Schematics over the controller unit in the bicycle.

Project Bicycle controller device

Filename BicycleController.fzz Rev 0

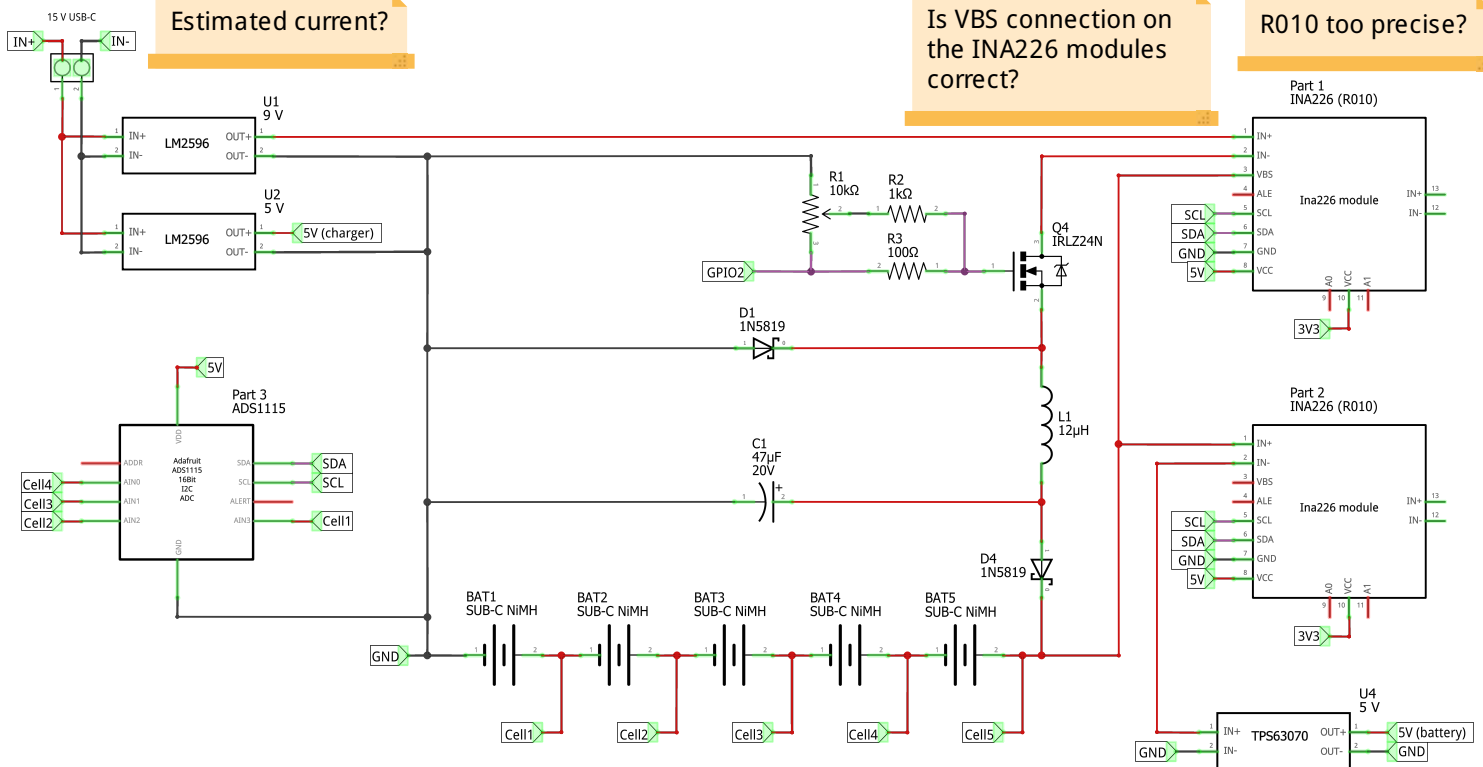
Estimated current?

Is VBS connection on the INA226 modules correct?

R010 too precise?

Have a GPIO for charging state?

Headlights

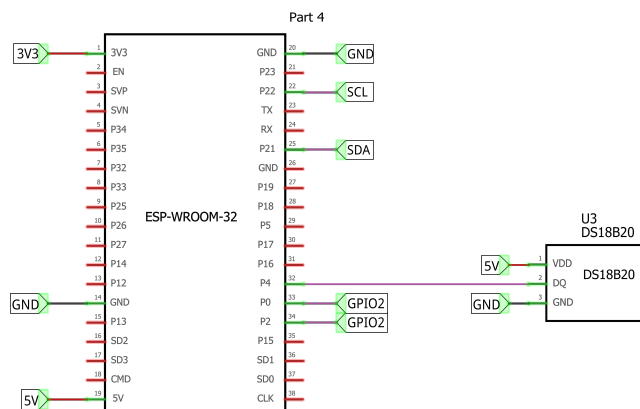
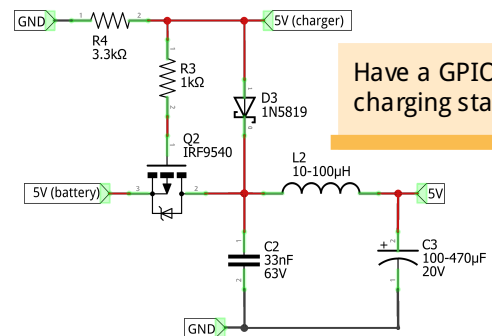
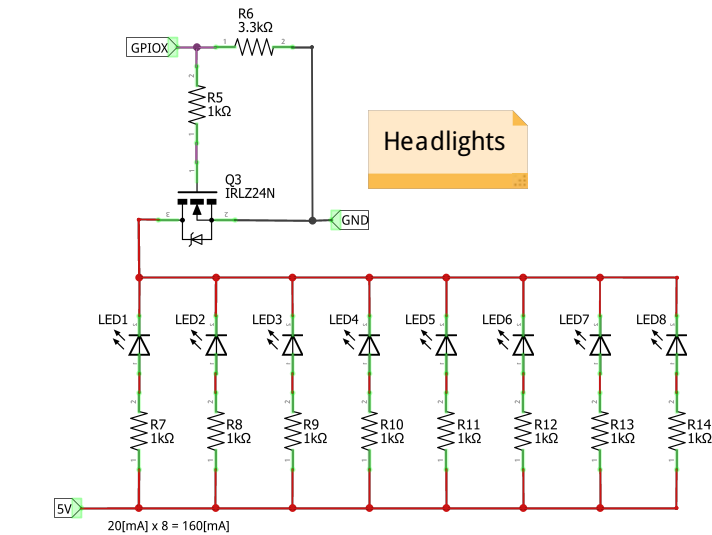
Need similar circuit for backlights and ambient lighting
